Report title:	Stage 1 Road Safety Audit Lowfield Road Railway Bridge Signalisation
Date:	December 2021
Document reference and revision:	211214-MM-Lowfield Road RSA 1
Prepared by:	Road Safety Initiatives
On behalf of:	Gleeson Regeneration And Homes

Project:	Proposed Residential Development, Land off Lowfield Road, Bolton upon Dearne – Phase 3
Report title:	Stage 1 Road Safety Audit Response Report
Prepared by:	
Name:	Martin Crabtree
Position:	Associate
Signed:	
Organisation:	Bryan G Hall
Date:	15 th December 2021
Approved by:	
Name:	James Pointon
Position:	Director
Signed:	
Organisation:	Bryan G Hall
Date:	15 th December 2021

This is the designers Response report for the Stage 1 Road Safety Audit dated 14th December 2021 for the proposed highway works to signalise the Lowfield Road Railway Bridge as part of the Proposed Residential Development, Land off Lowfield Road, Bolton upon Dearne – Phase 3.

Title: TRAFFIC SIGNAL SIGNALS LAYOUT

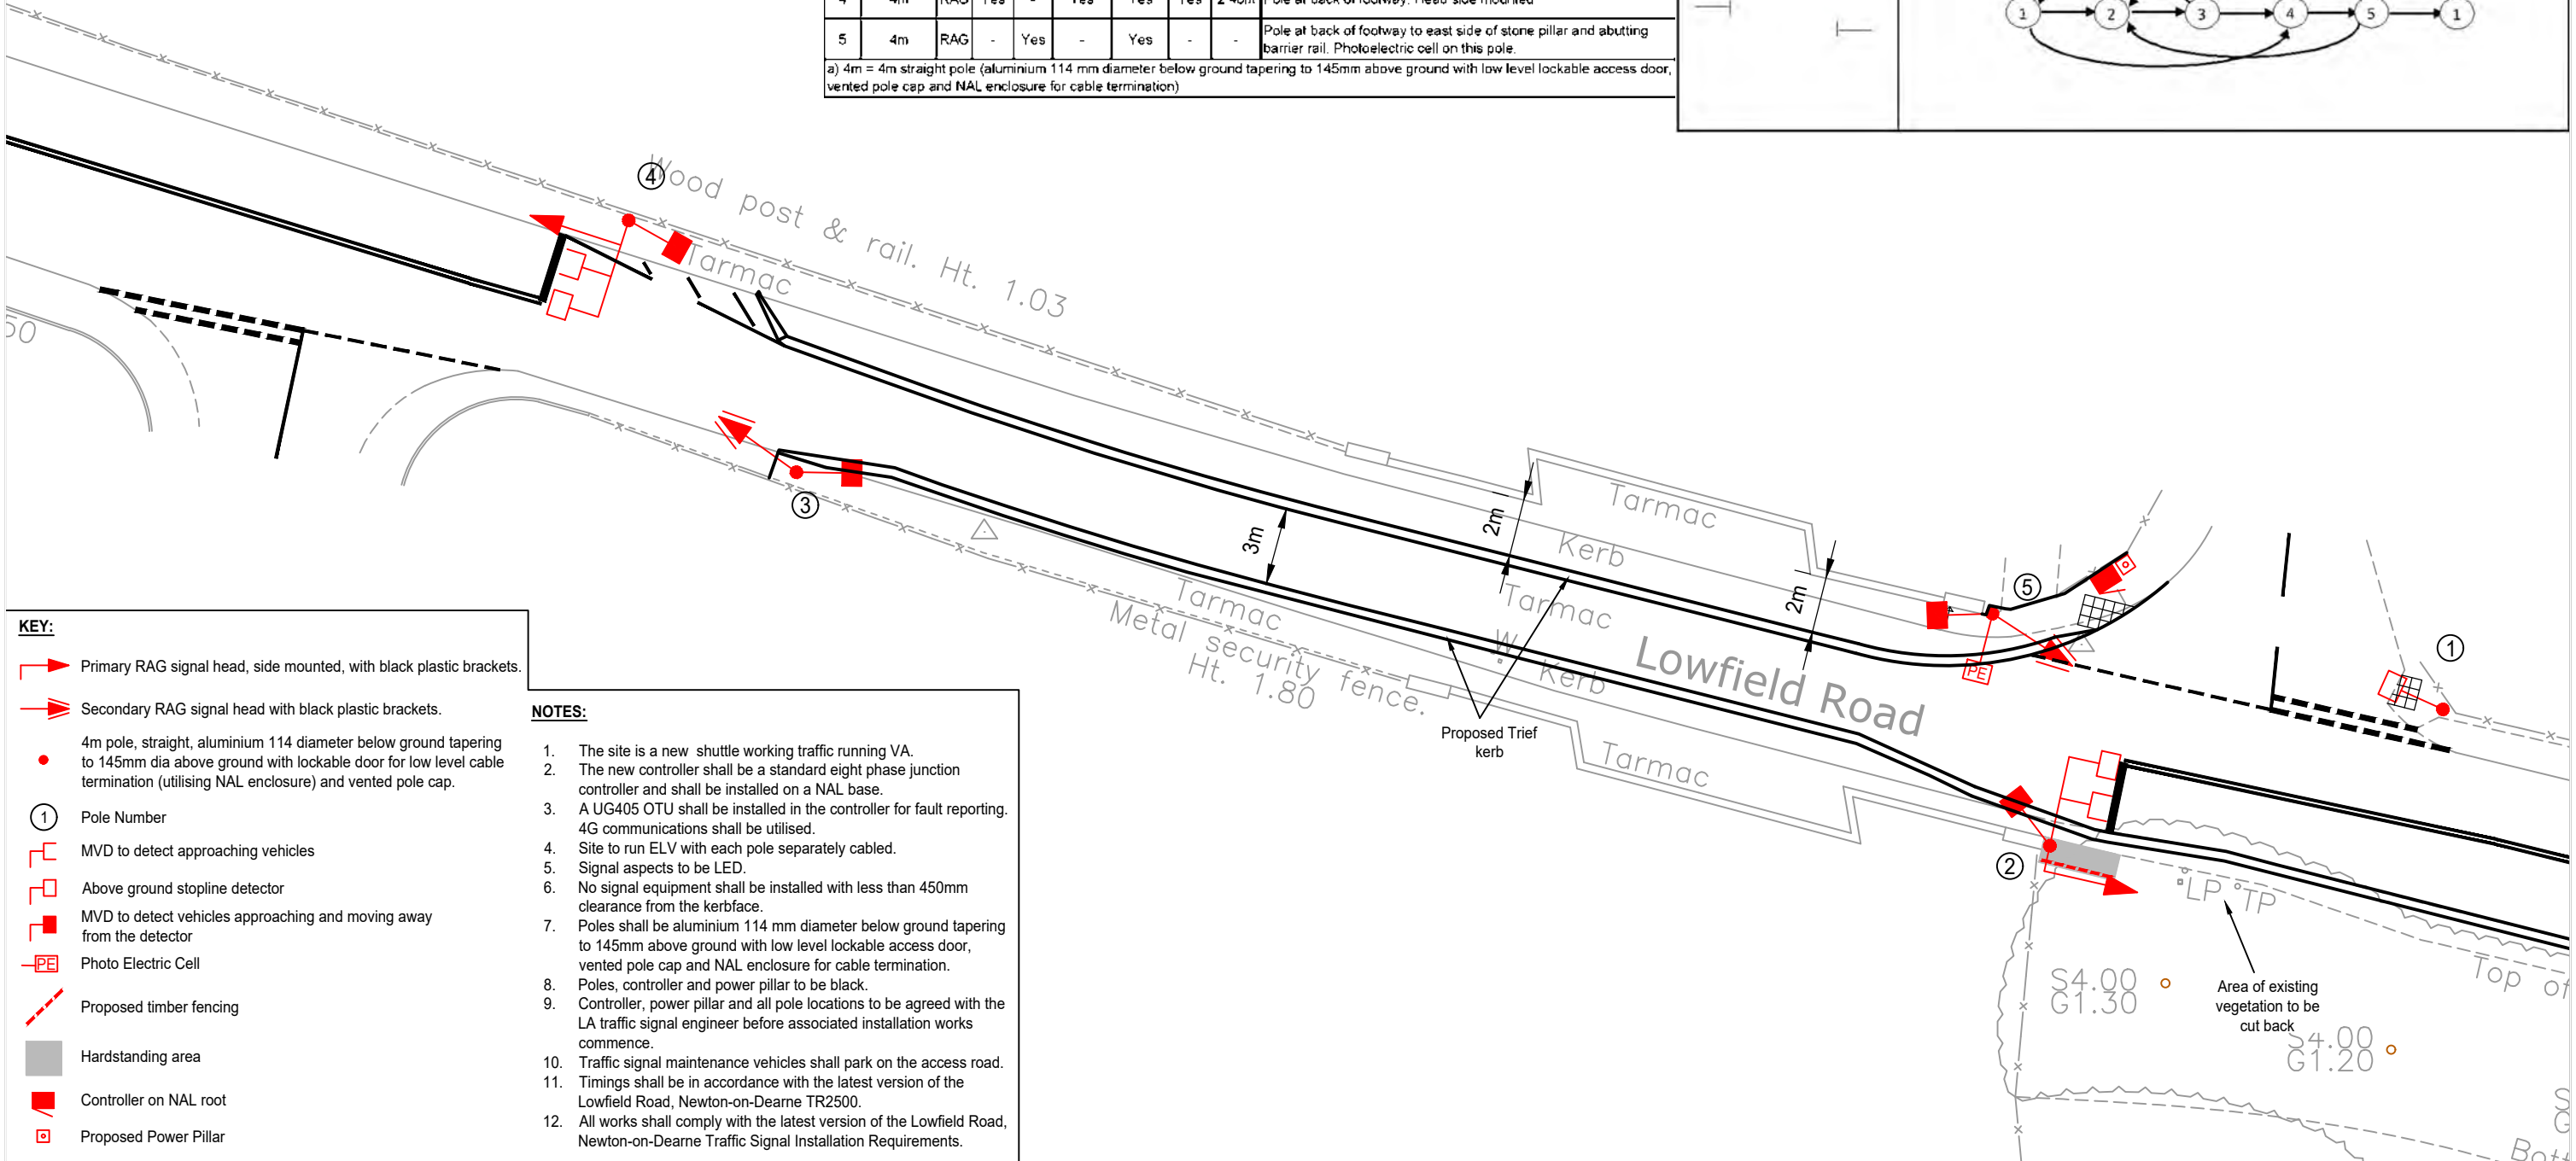
<p>Problem 2.1.2: Potential for overtaking and head-on conflicts.</p>	<p>It is recommended that the risk of overtaking is mitigated e.g., by providing 'prohibit' double-white-lines along both approaches to the traffic signal stop lines.</p>	<p>The proposed scheme has been updated to show 'prohibit' double-white-lines along both approaches to the traffic signal stop lines on drawing numbers 20/237/DE/1300/001 Rev B and 20-237-DE-1300-002 Rev B.</p>

<p>Problem 2.2.1: Potential for a conflict involving a cyclist and an overtaking vehicle.</p>	<p>It is recommended that there is a mitigation measure for the potential 'squeeze' problem for cyclists. The running lane could be made narrower so that vehicle drivers were discouraged from trying to pass cyclists or made wider to allow for safe overtaking. Suitable warning signs or markings could also be provided.</p>	<p>The proposed scheme has been updated to show a 3.0m running lane in line with LTN1/20 across the bridge to allow cyclists to take up the primary position and to discourage vehicle drivers from attempting to pass a cyclist on drawing numbers 20/237/DE/1300/001 Rev B and 20-237-DE-1300-002 Rev B.</p> <p>Suitable warning signs or markings will be provided and agreed at the detailed design stage.</p>		
<p>Problem 2.2.2: Potential for a conflict involving a pedestrian crossing the access road.</p>	<p>It is recommended that a safe, accessible, and convenient crossing is provided across the un-named access road.</p>	<p>The proposed scheme has been updated to show amendments to the footway on the south side together with dropped kerbs and tactile paving on drawing numbers 20/237/DE/1300/001 Rev B and 20-237-DE-1300-002 Rev B.</p>

B	16/12/21	Proposed layout updated following RSA comments	JJ	MC
Rev:	Date:	Amendment:	DRN	CHK
Client:		GLEESON REGENERATION AND HOMES		
Project:		LOWFIELD ROAD BOLTON ON DEARNE		
Drawing No:	20/237/DE/1300/001	Revision:	B	
Job No:	20-237	Date:	09/06/2020
